PROJECT COMMENTS

SP2023-004 Amended Site Plan for a Car Wash 2525 HORIZON RD CASE MANAGER: CASE MANAGER PHONE: CASE MANAGER EMAIL: Bethany Ross (972) 772-6488 bross@rockwall.com

PLANNING AND ZONING COMMISSION CASE MEMO

TO:	Planning and Zoning Commission
DATE:	February 14, 2023
APPLICANT:	Ibrahim Kassem
CASE NUMBER:	SP2023-004; Amended Site Plan for a Car Wash

SHEET TITLE: PROPOSED SITE PLAN SHEET 3-6

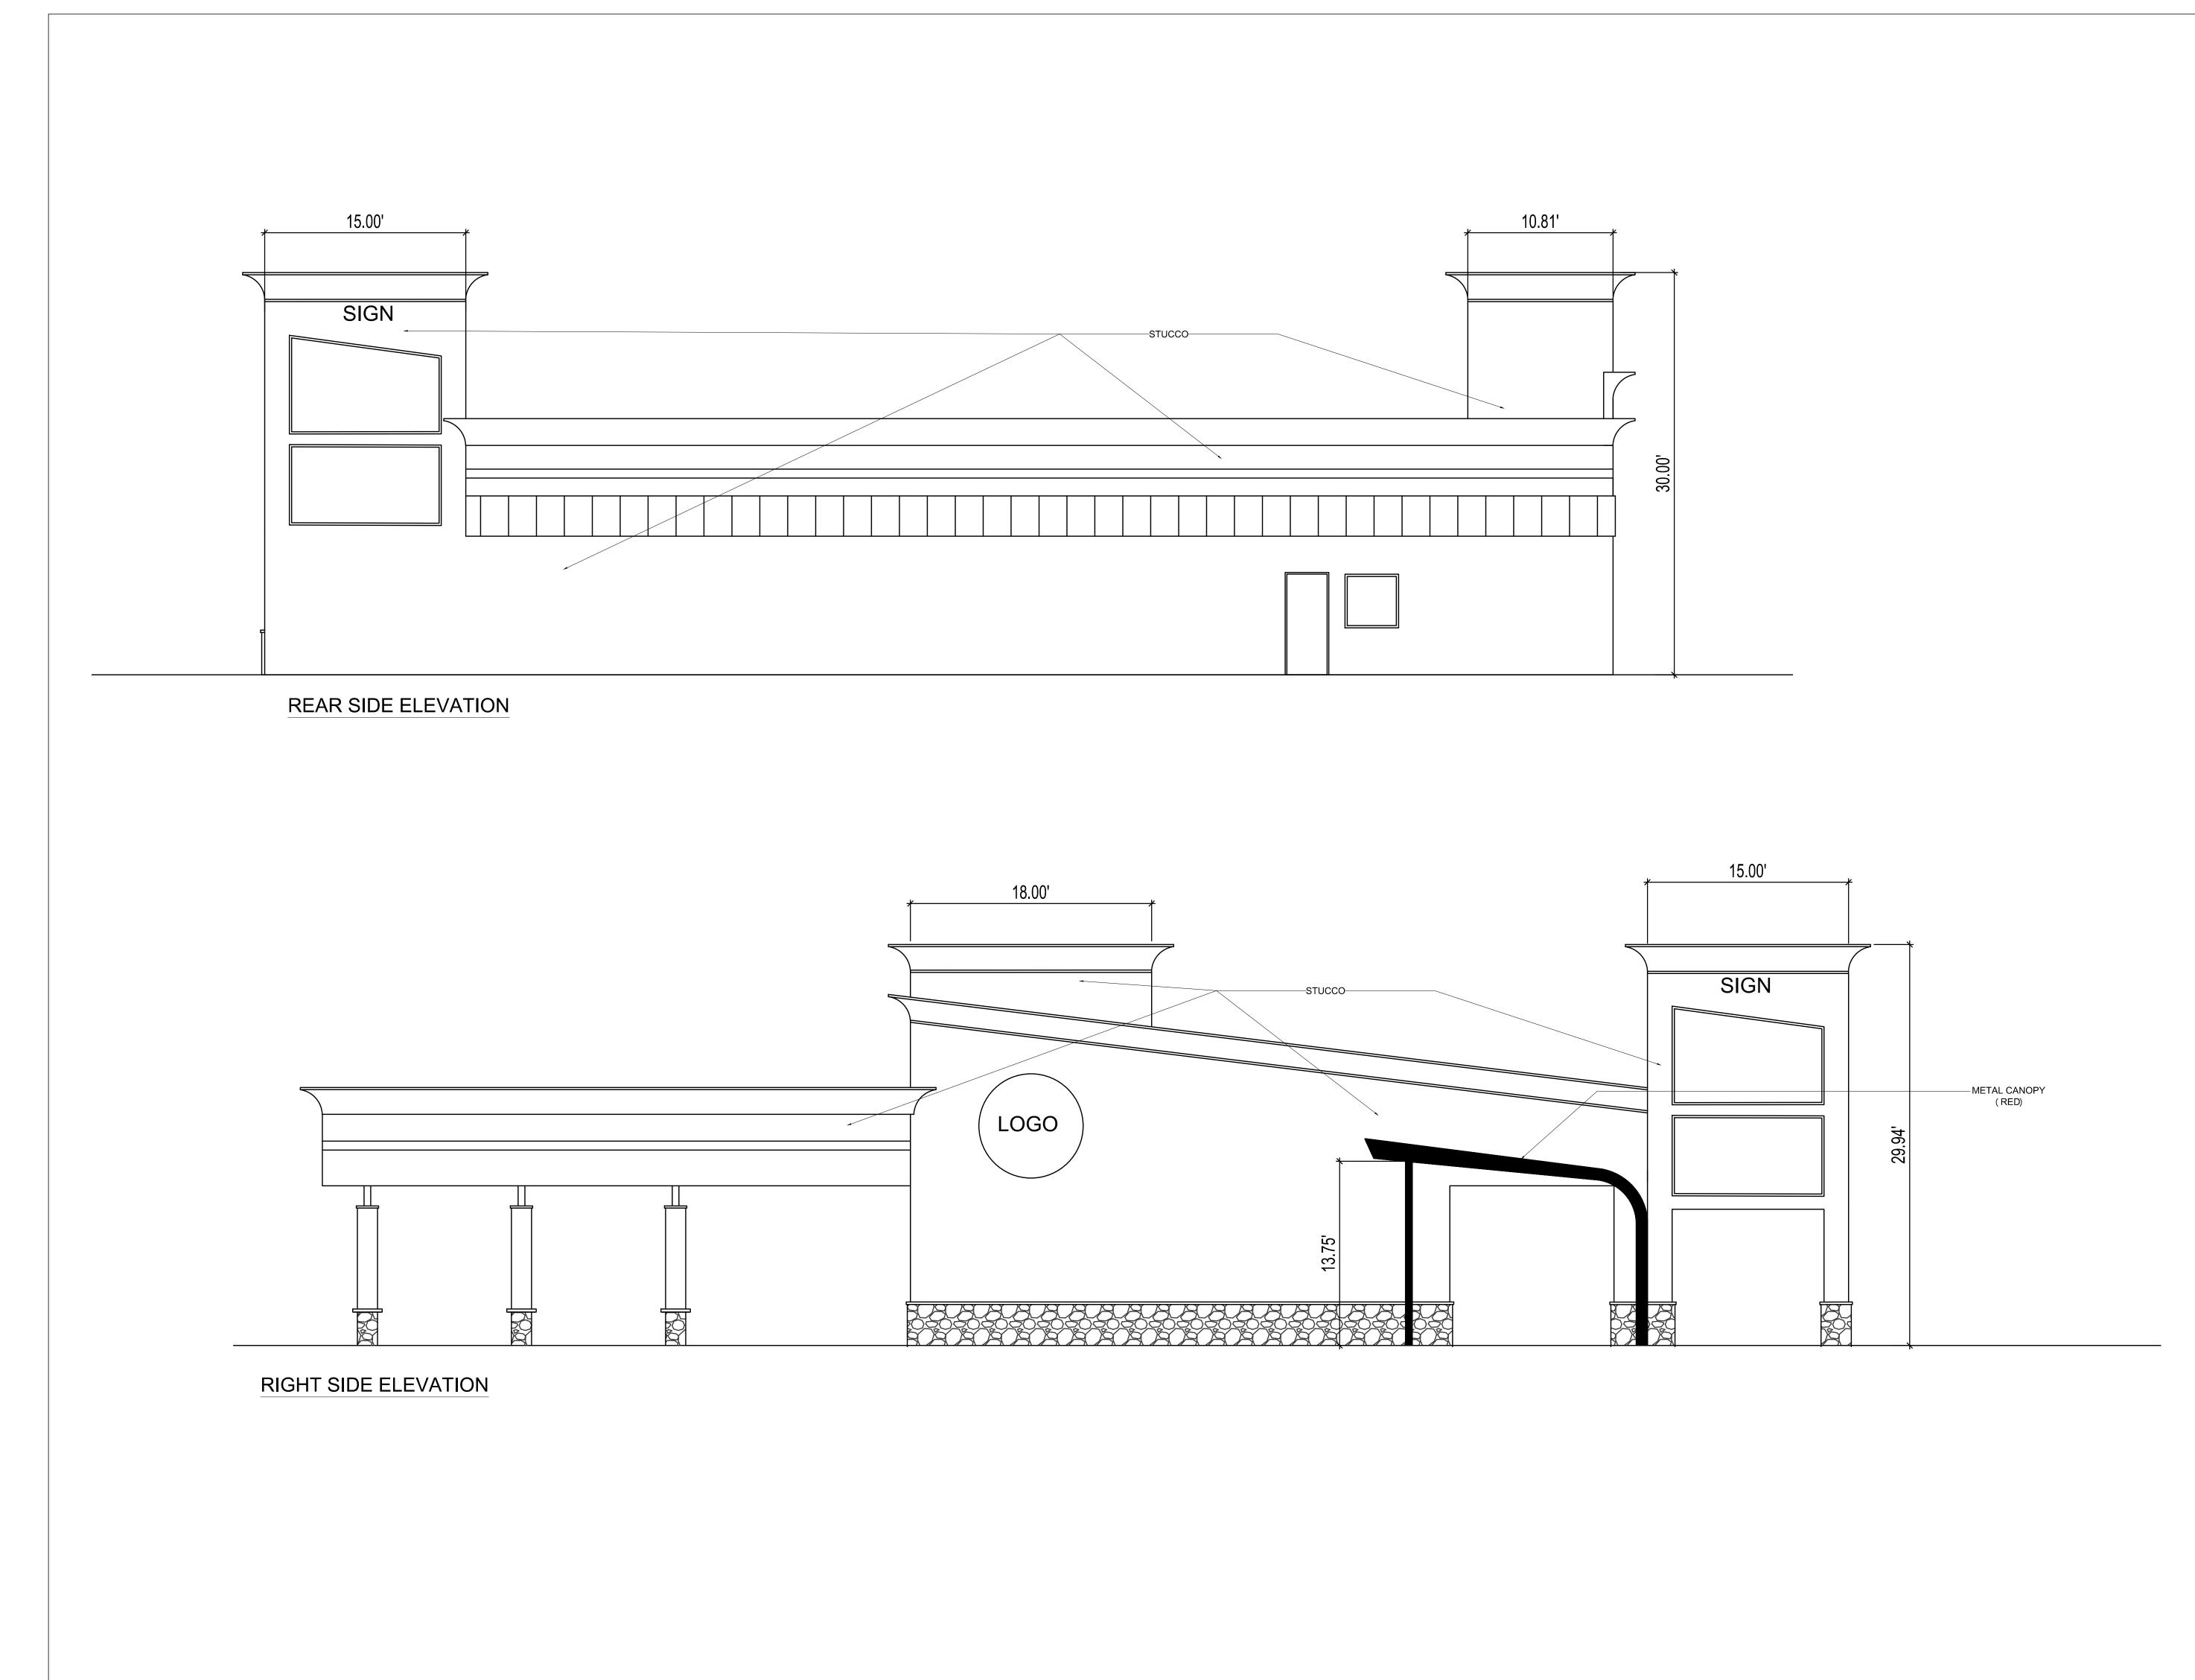
M.7 Site Plan

(1) Indicate all existing and proposed fire hydrants. (Subsection 03.04.B, of Article 11, of the UDC)

(2) Indicate the location of all proposed signage on the site plan. If removing the existing sign, a new sign cannot be placed in the same location. (Subsection 06.02.F, of Article 05, of the UDC)

(3) Smooth faced CMU Block shall be prohibited. Please indicate that split-face CMU will be used on those façades. (Subsection 06.01(C).1(a), of Article 05, of the UDC)

<u>Sheet title</u>: PROPOSED ELEVATIONS II SHEET 6-6

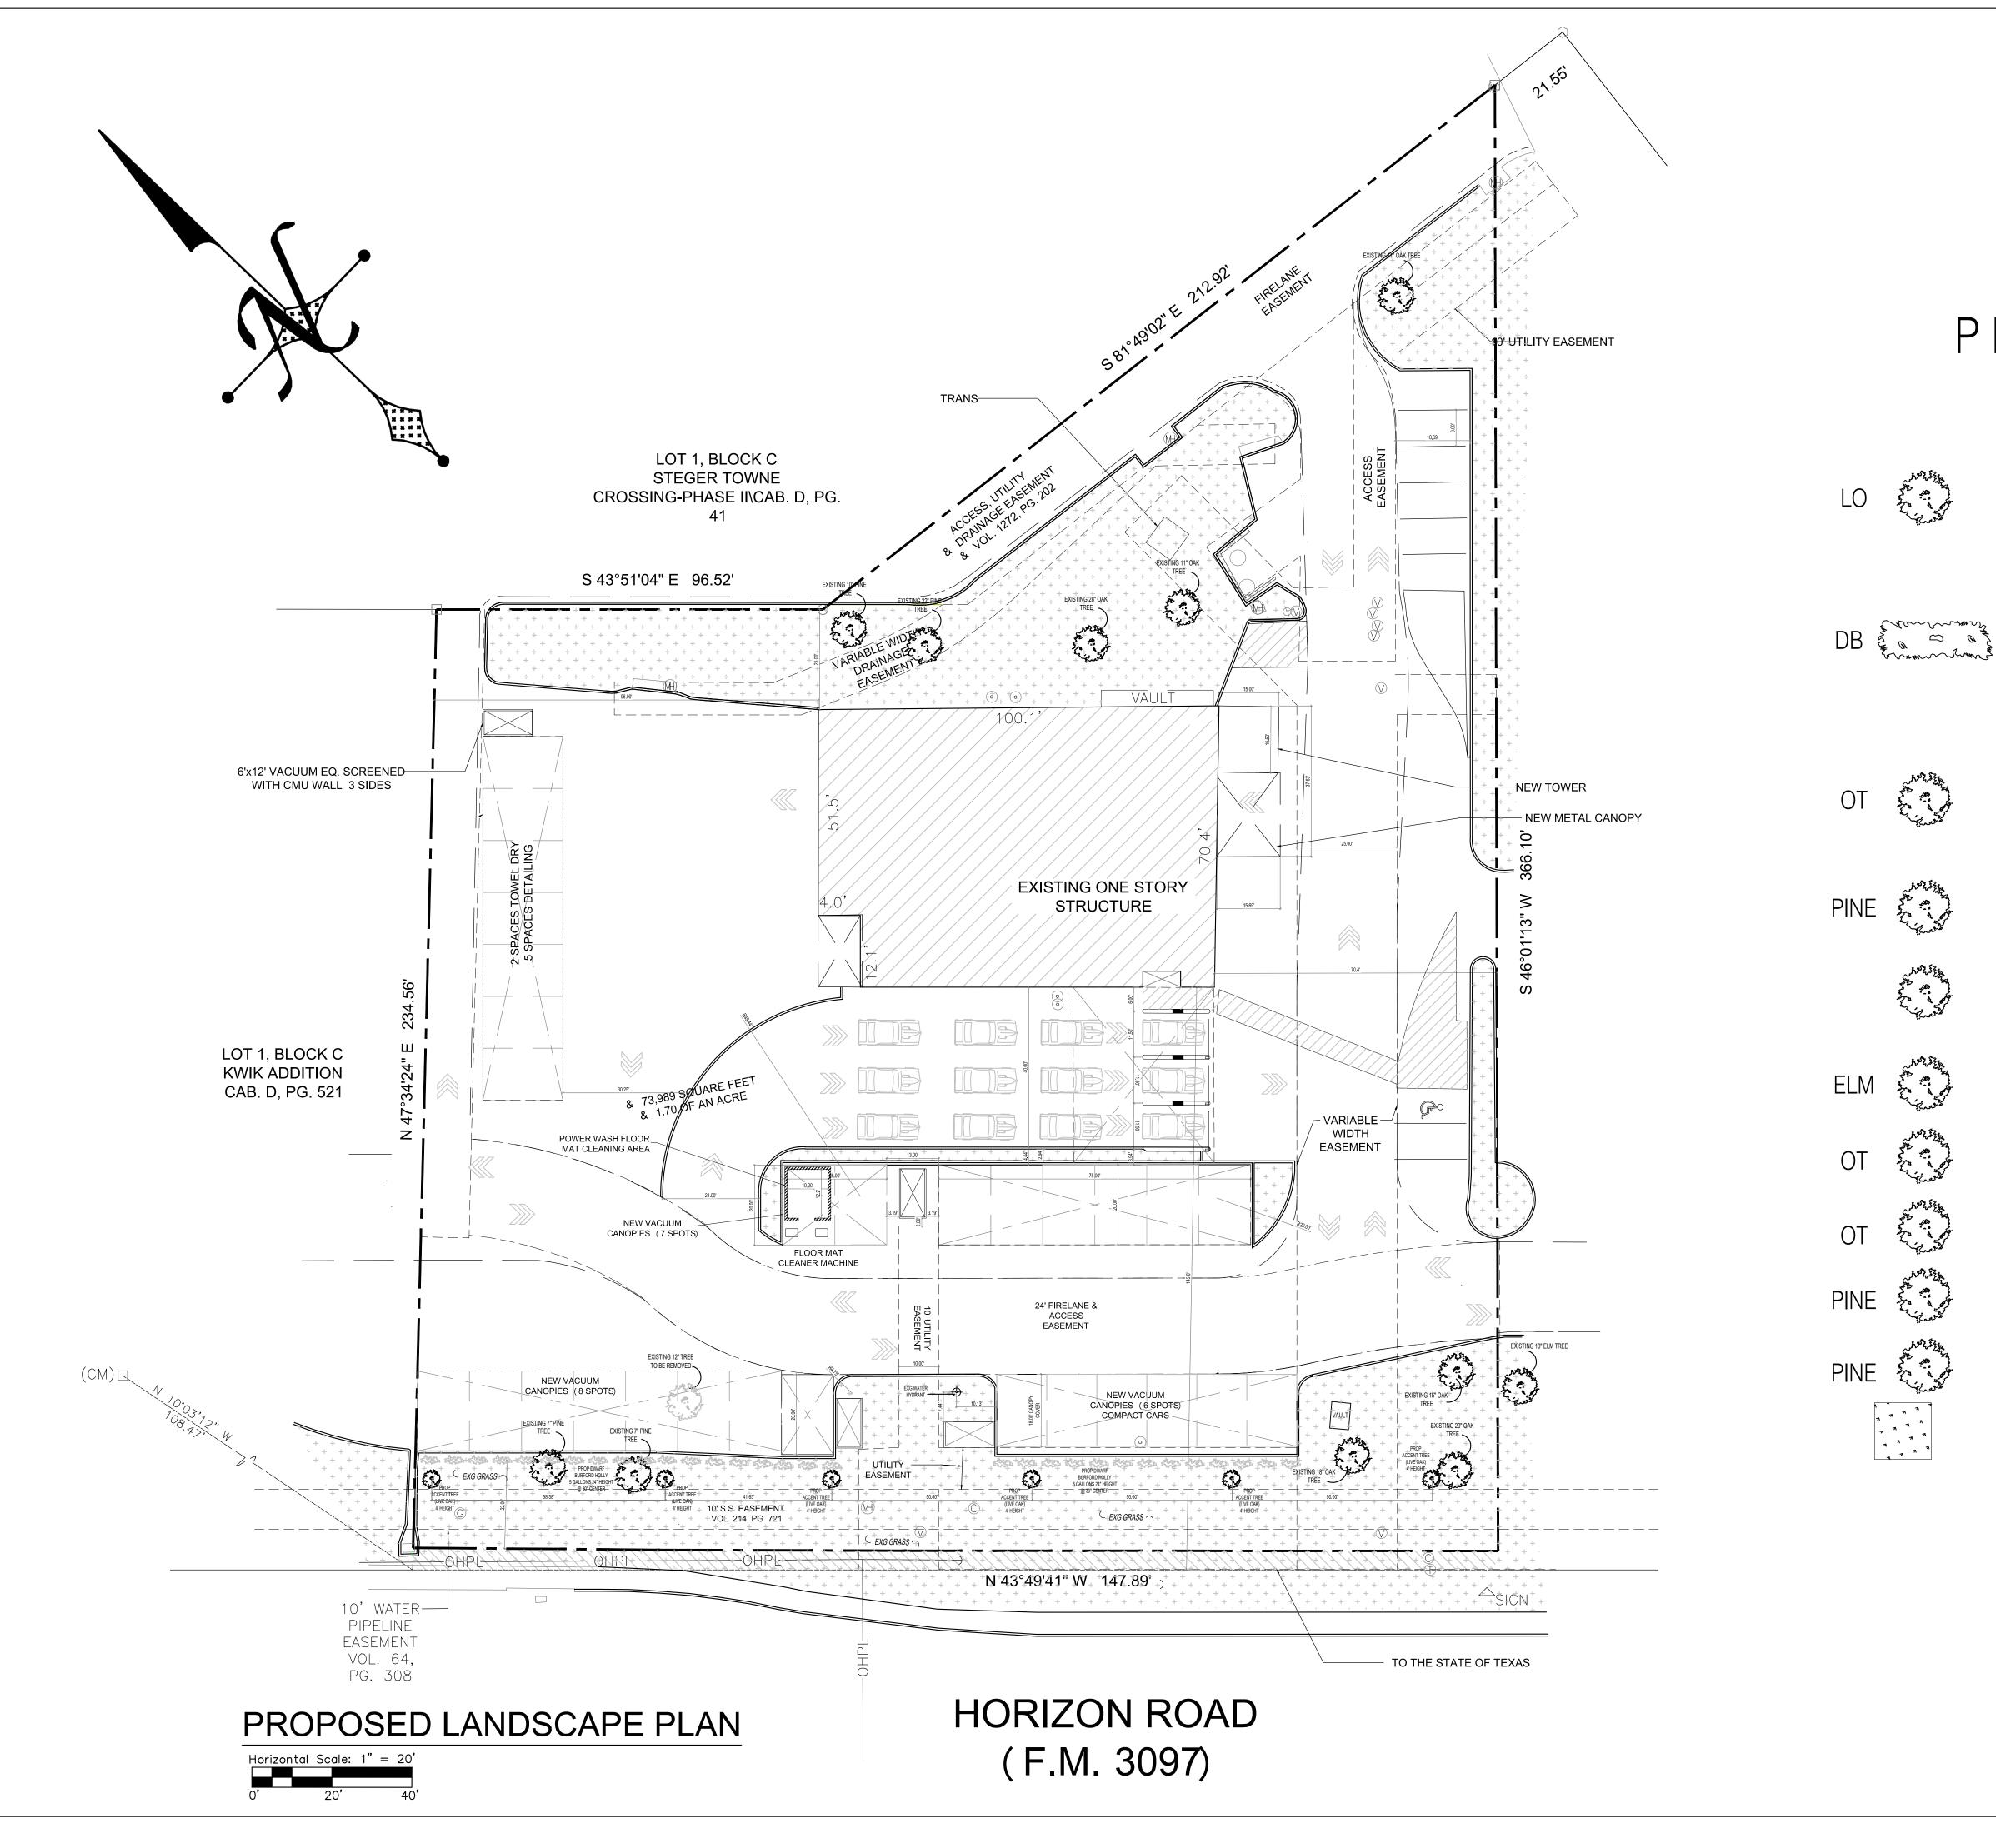
- M.9 Building Elevations
- (1) Provide the same site data information as the Site Plan.
- (2) Provide exterior elevations for all four (4) sides of the building and indicate which facade is facing Horizon Road.

- (3) Please provide a numeric and graphic scale. (Subsection 03.04.A, of Article 11, of the UDC)
- (4) Indicate the surface area (square feet) of each façade and the percentage and square footage of each material used on that façade. (Subsection 04.01, of Article 05, of the UDC)

- (5) Provide specifications and description of all proposed building materials. (Subsection 04.01, of Article 05, of the UDC)
- (6) Indicate roofing materials and color.

- (7) Indicate all vertical and horizontal measurements.
- (8) Indicate that the back of the parapet will be finished in the same materials as the front of the parapet.

- (9) Indicate all roof mounted mechanical equipment and how these will be screened from view. (Subsection 01.05.C, of Article 05, of the UDC)
- (10) Provide elevations of the canopies over the vacuum bays.
